Eastern Newfoundland Offshore Geophysical, Geochemical, Environmental and Geotechnical Programs 2015-2024

Environmental Assessment Addendum and Amendment

May 2016

EA Report, Figure 1.1: ExxonMobil Eastern Newfoundland Offshore Geophysical, Geochemical, Environmental and Geotechnical Programs, 2015-2024 (NOTE: Original Project and Study Areas and base map / licencing information)

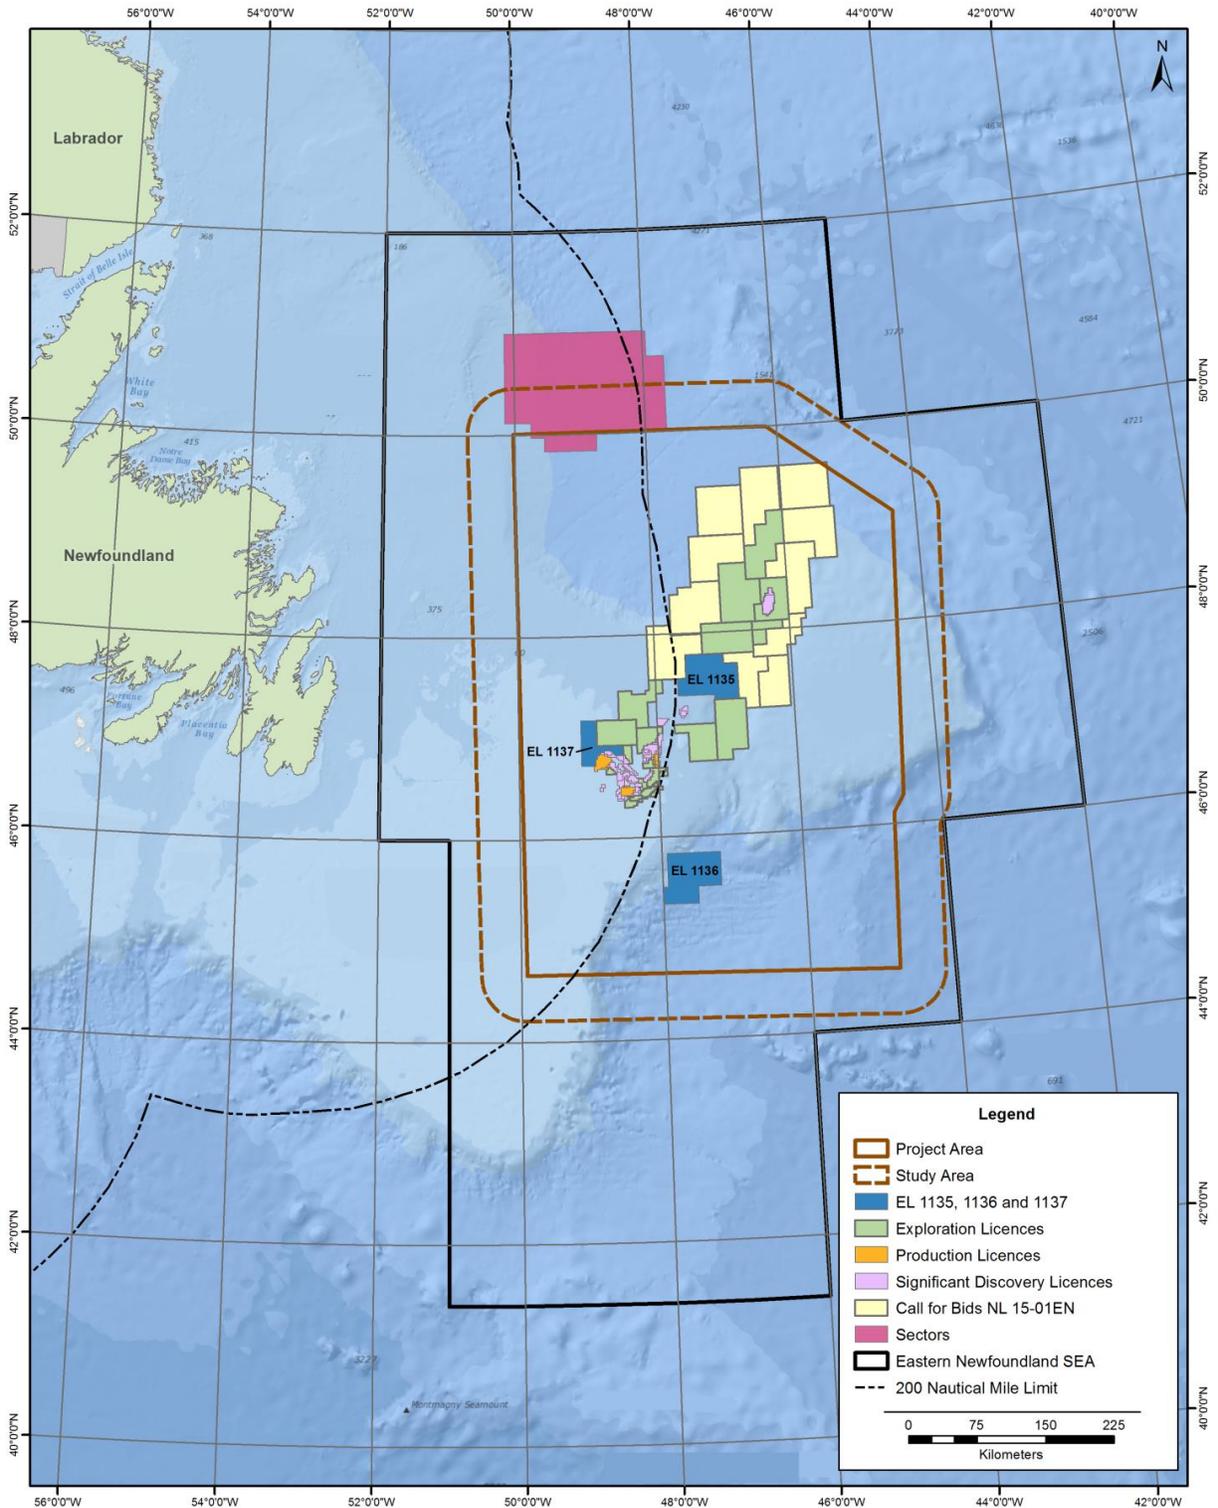
Figure 1.1 (page 2), Figure 2.1 (page 10) and Figure 3.2 (page 28) - While these figures (and other similar figures in the EA) show a polygon labelled “Sectors” located immediately outside the NW boundary of the Project Area it is not clear what this area represents as it has not been defined or referenced within the EA. This should be clarified and an indication provided as to the nature of this area and its relationship to the activities undergoing EA.

ExxonMobil Response: The Figures throughout the EA Report use a common base map and scale to optimize the utility and comparability of the associated mapping and the Project and environmental baseline information illustrated therein. This has included, for general reference, all of the various licences, calls for bids areas and other regulatory boundaries that are relevant to the offshore oil and gas industry within the Study Area (as administered by the C-NLOPB) as of the time of EA Report writing. This includes licences and other areas and boundaries which are not necessarily directly relevant to the Project itself, as illustrated in Figure 1.1 of the EA Report (reproduced below, for reference).
